This is an official notice to the DOE registering my objections to any plans being considered to move 13 million tons of contaminated uranium tailings from Grand County, Utah to East Carbon, Carbon County, Utah.

# Comments regarding Moab Project EIS

Re: Comments of Draft Moab Project EIS Process.

gure 3. Oblique aerial photograph (courtesy of DOE). Markings in white were added by the mmilitee. Directions, distances, and boundaries are approximate, and the distance scale presponds roughly to the location of the pile in the picture.

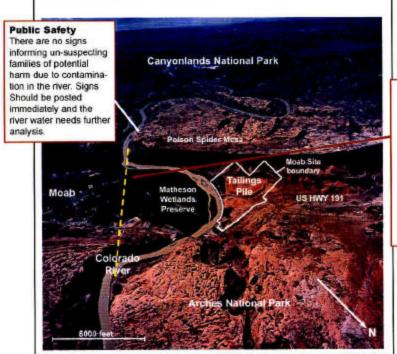
The proposed construction widening Highway 191 was mentioned but not elaborated on by DOE. What effect will the construc-

What effect will the construction have on the tailings which butt up to the highway at its north side?
